Our ref: DOC25/644491
Your ref: SSD-6764-Mod-3

Wilpinjong Coal Mine – Pit 8 Extension – Modification 3

Attachment A – DCCEEW's Recommendations

Attachment D - CPHR's Detailed Comments

Figure 1 Microbat breeding habitat immediately adjacent to proposed mining operations, and 100m protection buffer

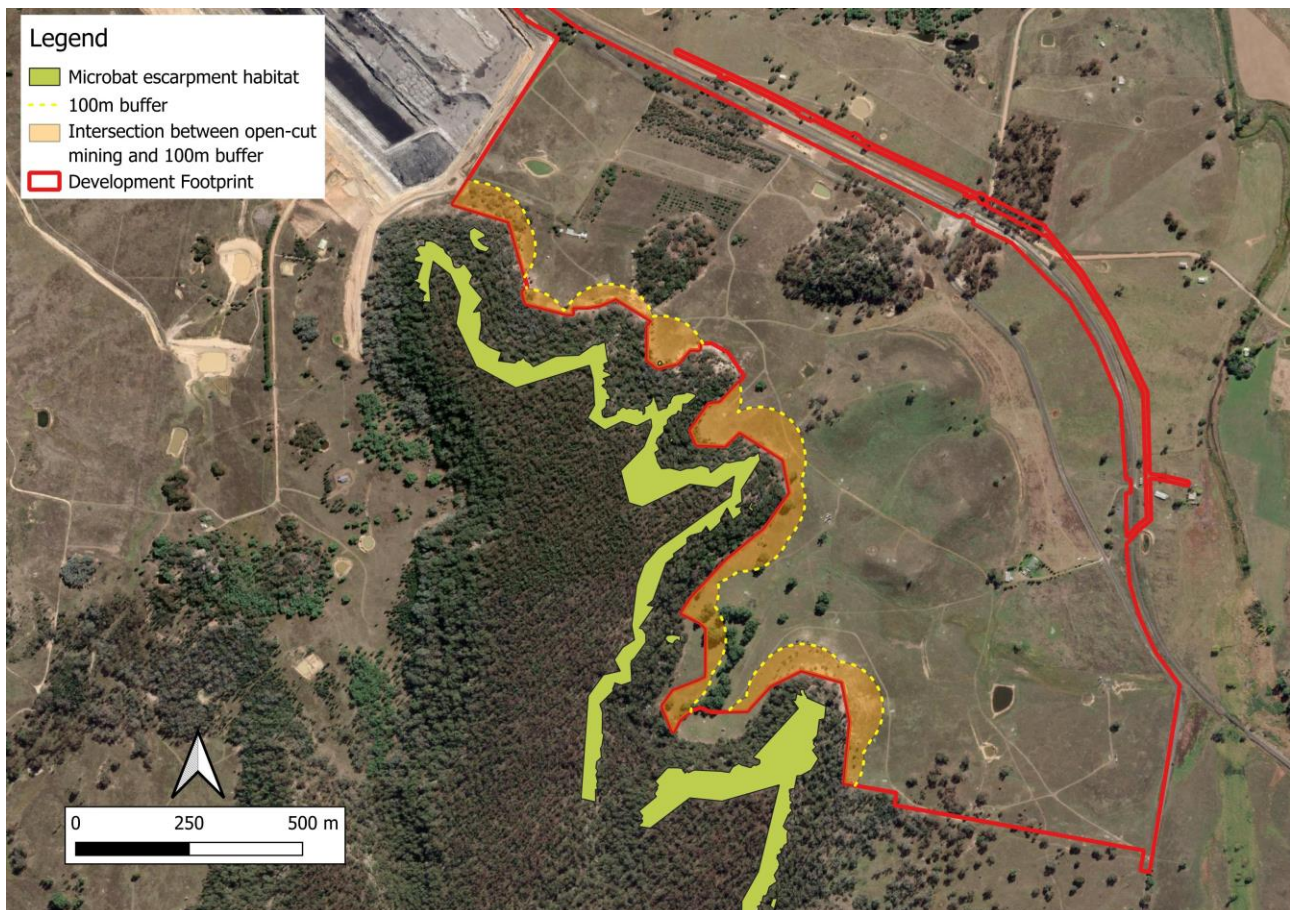
Approximately 24 ha of escarpment habitat has been mapped immediately adjacent to the proposed development. Much of the western portion of the proposed open-cut mining pit encroaches within 100 metres of this habitat (see Figure 1 below). CPHR considers this area a high priority for impact avoidance and mitigation.

Additional mitigation and minimisation measures should be specifically developed to address potential disturbance to bat colonies within the adjacent escarpment habitat, in accordance with Section 8.2.2 of the BAM 2020. If residual impacts remain likely, or uncertain after mitigation strategies have been considered, CPHR recommends further avoidance measures. This should include reducing the development footprint to maintain a minimum 100-metre buffer from the escarpment habitat.

- 6.1 Develop additional mitigation and minimisation measures to address potential disturbance to bat colonies within the adjacent escarpment habitat. Where residual impacts remain likely, or uncertain after mitigation strategies have been considered, apply further avoidance measures, including reducing the development footprint to maintain a minimum 100-metre buffer from the escarpment habitat.

Figure 3 Extract from the Groundwater Impact Assessment showing the absence of a proposed groundwater monitoring station adjacent to Goulburn River National Park.

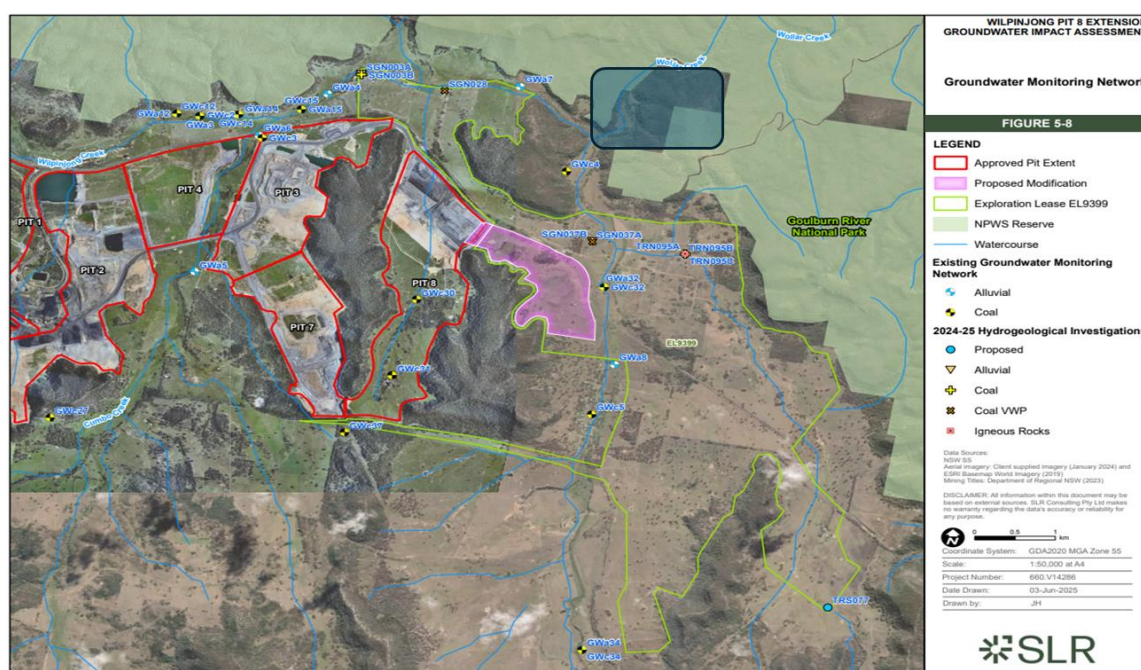
The proposed modification is an upgradient activity that is predicted to affect the watercourses draining toward the Goulburn River in Goulburn River National Park (GRNP) via Wilpinjong and Wollar creeks. In the Groundwater Impact Assessment (SLR 2025⁵) baseflow contributions to an unnamed tributary of the Goulburn River are predicted to decrease by 1.8 mega litres (ML)/year during the mining period and by 4ML/year during the early recovery period (post-mining). It is not clear how those predictions will be validated, as there is not a ground water monitoring location proposed near the GRNP (See Figure 3 below).

- 13.1 Install a ground water monitoring location downstream of Wollar Creek to validate predictions from the groundwater impact assessment and its contribution to cumulative groundwater drawdown.

Figure 4 Extract from the Groundwater Impact Assessment showing that maximum cumulative drawdown will be to the east, west, and north of the Pit 8 Extension area.

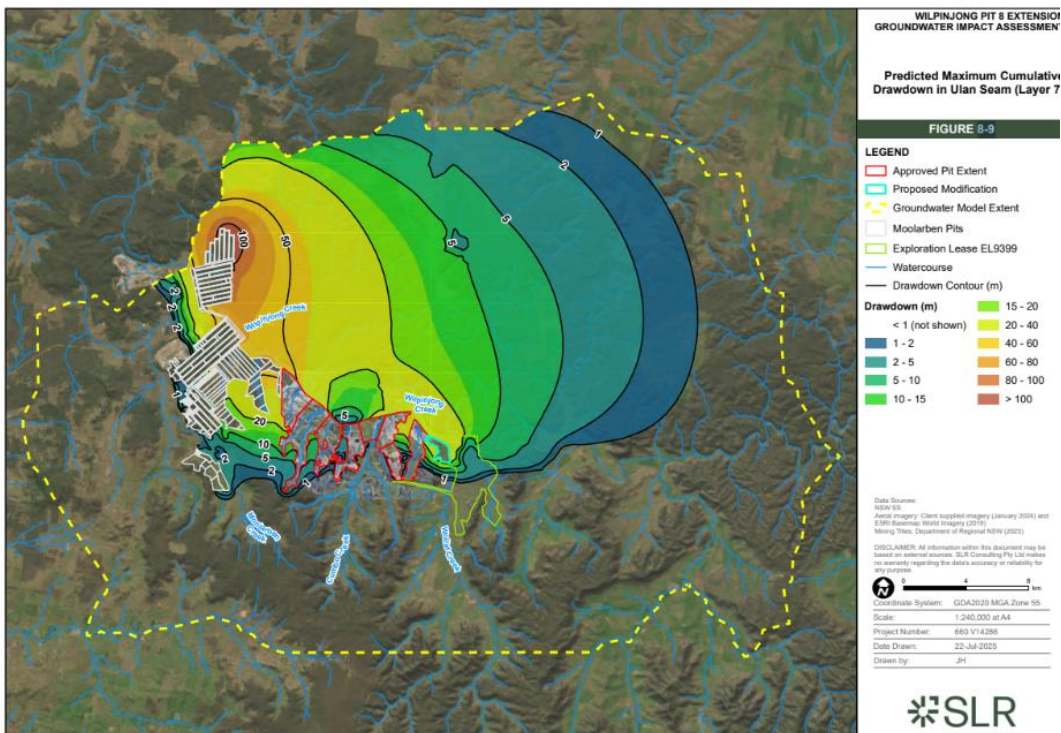
In addition, the assessment predicts the maximum cumulative impacts, which include the modification along with existing and approved operations, on groundwater levels and surface water baseflow. The cumulative baseflow loss is predicted to become negative approximately 30 years post-mining (in 2063). This is attributed to the hydraulic properties of the waste rock in backfilled pits allowing for increased rainfall recharge and subsequent discharge to surface water (See Figure 4).

Figure 5 Extract from the modification report, showing uncleared areas where enhancement conservation area C should be increased.

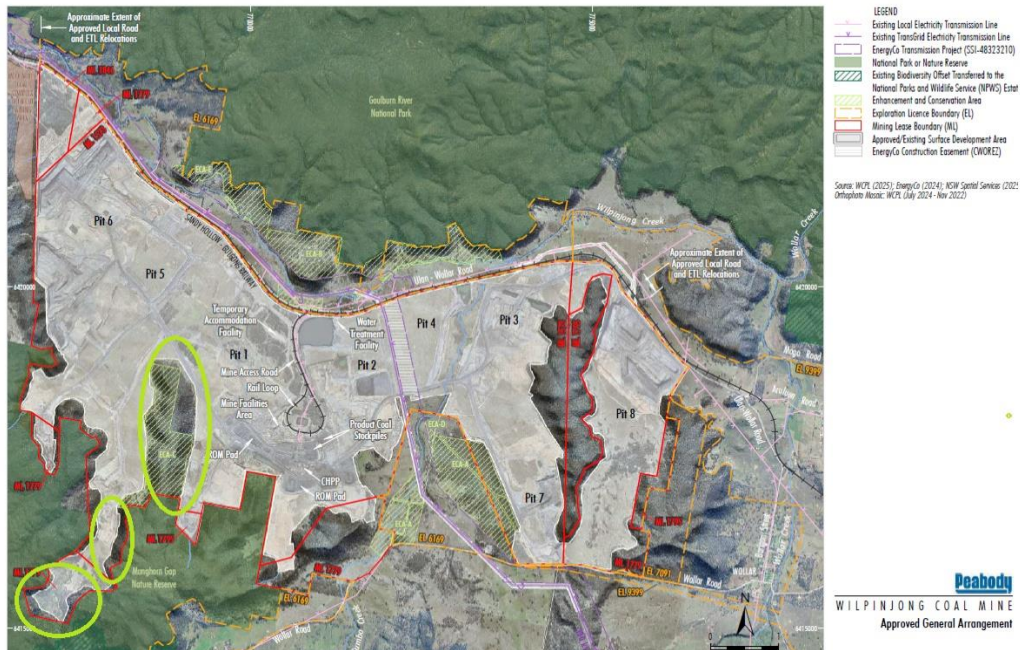
Figure ES-3 of the modification report depicts the layout of Wilpinjong Mine, including enhancement conservation areas A-E. NPWS support the establishment of enhancement conservation areas B, C and E which act as buffers to adjoining NPWS managed lands.

NPWS note that enhancement conservation area C adjoins Munghorn Gap Nature Reserve and contains rock shelters and bat habitat. There are some minor areas of uncleared habitat adjacent to approved pits 1 and 5 that should be incorporated into enhancement conservation area C, as this would create an increased buffer between mining operations and Munghorn Gap Nature Reserve.

- 14.1 Increase proposed enhancement conservation area C to be inclusive of adjacent uncleared vegetation as depicted in Figure 5 of this response.
